HISTORIC AND DESIGN REVIEW COMMISSION

HDRC CASE NO: 2018-196
ADDRESS: 121 BUFORD
LEGAL DESCRIPTION: NCB 1369 BLK 6 LOT S 81.3 FT OF 5
ZONING: R-4, H
CITY COUNCIL DIST.: 2
DISTRICT: Dignowity Hill Historic District
APPLICANT: Chris Williams
OWNER: Chris Williams
TYPE OF WORK: Landscaping elements, hardscaping, insallation of planters, landscaping walls, fencing
APPLICATION RECEIVED: April 18, 2018
60-DAY REVIEW: June 17, 2018

Exhibit 2: Original design with notes addressing non-compliant findings:

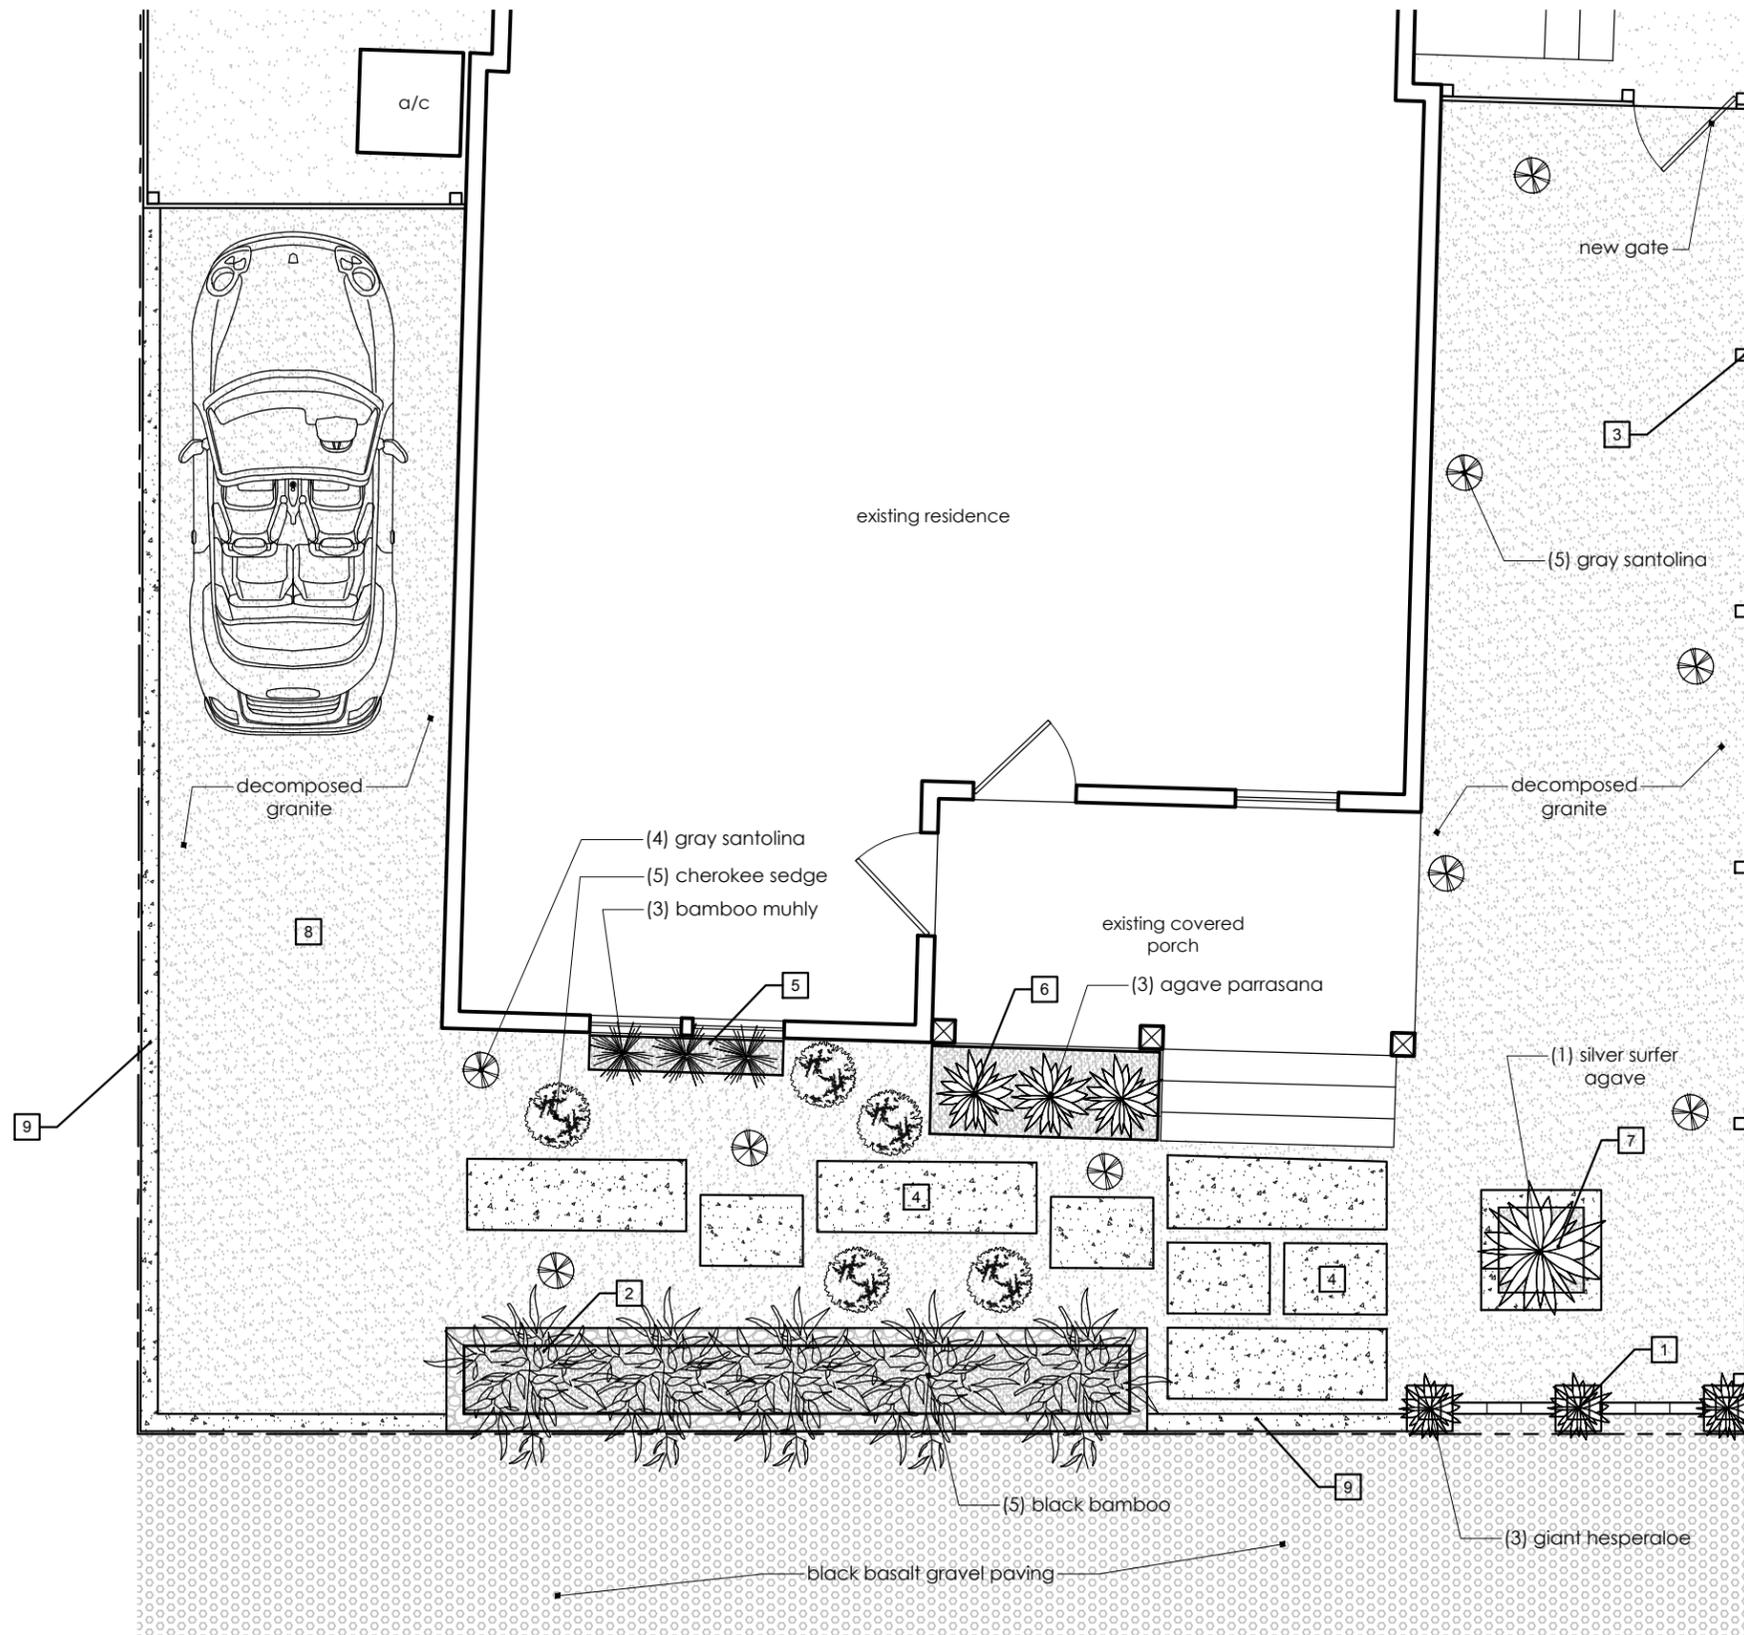
#5 and #6. Wood trim to be added to planters (window and porch)

#8. Gabion wall will be replaced with wood planter of same dimensions

#2. City called to install sidewalk

#7. Low ground concrete planter from original plan was not installed (not pictured)

#3. More plants to be added to side yard

#1. Side fence reduce to 4 ft

#4. Pavers to be replaced with crushed granite walkway

#9. Solar screen to be removed and replaced with wood planter of same height and depth of #8
